# **VOLUME 16**

## **CNP UNITS 1 AND 2 IMPROVED TECHNICAL SPECIFICATIONS CONVERSION**

### **ITS CHAPTER 5.0 ADMINISTRATIVE CONTROLS**

**Revision 0**

6.1.1

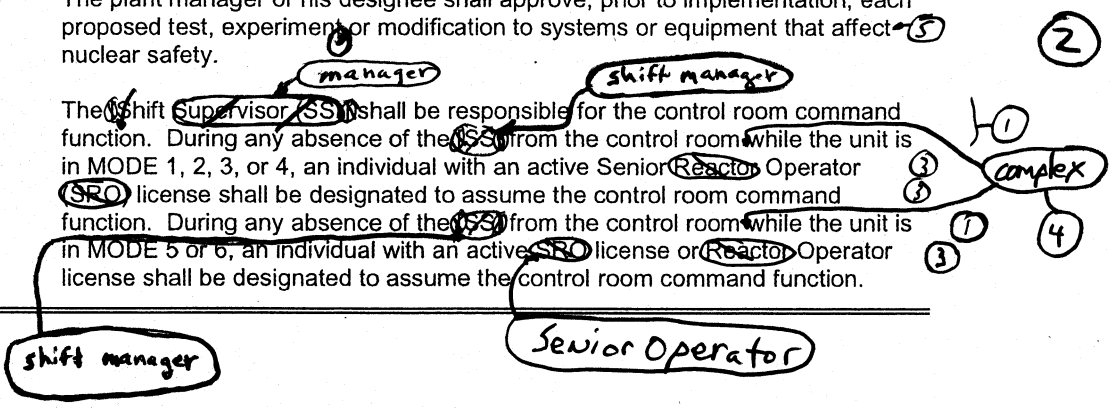
DOC M.1

The plant manager or his designee shall approve, prior to implementation, each proposed test, experiment or modification to systems or equipment that affect nuclear safety. (5)

- M.1 ITS 5.1.1 requires that the plant manager or his designee approve, prior to implementation, each proposed test, experiment, or modification to systems or equipment that affects nuclear safety. The CTS does not include this requirement. This changes the CTS by adding an approved requirement for the plant manager or his designee.

The purpose of the ITS 5.1.1 requirement is to provide additional assurance that the plant manager has direct responsibility for overall unit operation. This change is acceptable because having the plant manager or his designee approve actions affecting nuclear safety is consistent with the CTS 6.2.1.b (ITS 5.2.1.b) requirement that the plant manager shall be responsible for overall unit safe operation and shall have control over those onsite activities necessary for safe operation and maintenance of the plant. This change is designated more restrictive because it adds a requirement for the plant manager or his designee to the CTS.

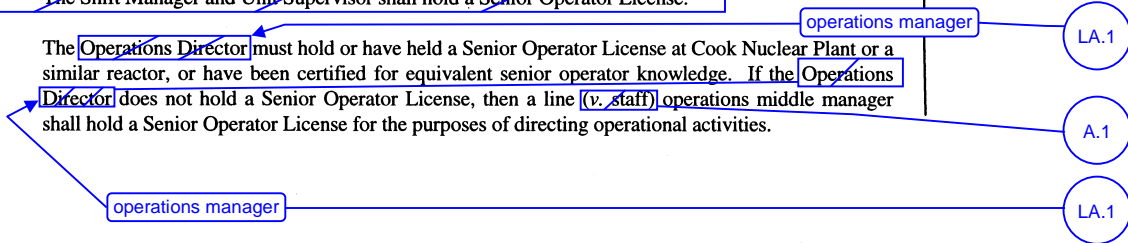
a. Each on duty shift shall be composed of at least the minimum shift crew composition shown in Table 6.2-1. LA.2

b. At least one licensed Operator shall be in the control room when fuel is in the reactor. In addition, while the unit is in Mode 1, 2, 3, or 4, at least one licensed Senior Operator shall be in the control room. A.3

- LA.2 (*Type 3 – Removing Procedural Details for Meeting TS Requirements or Reporting Requirements*) CTS 6.2.2 and Table 6.2-1, including footnote #, provide minimum shift crew composition requirements. ITS 5.2.2 only includes the minimum shift crew composition requirements that are not already included in 10 CFR 50.54. This changes the CTS by moving the minimum shift crew composition requirements addressed by 10 CFR 50.54 to the Technical Requirements Manual (TRM).

The removal of these details, which are related to meeting Technical Specification requirements, from the Technical Specifications is acceptable because this type of information is not necessary to be included in the Technical Specifications to provide adequate protection of public health and safety. The minimum shift crew composition requirements for licensed operators and senior operators are also contained in 10 CFR 50.54(k), (l), and (m) and do not need to be repeated in the Technical Specifications. The minimum shift crew composition requirements for non-licensed operators are transferred from CTS Table 6.2-1 to ITS 5.2.2.a and the minimum shift crew composition requirements for the STA are transferred from CTS Table 6.2-1 to ITS 5.2.2.f. The relocation of the details of the minimum shift crew composition requirements to the TRM is acceptable considering the controls provided by regulations and the remaining requirements in the Technical Specifications. Also, this change is acceptable because these details will be adequately controlled in the TRM. Any changes to the TRM are made under 10 CFR 50.59, which ensures changes are properly evaluated. This change is designated as a less restrictive removal of detail
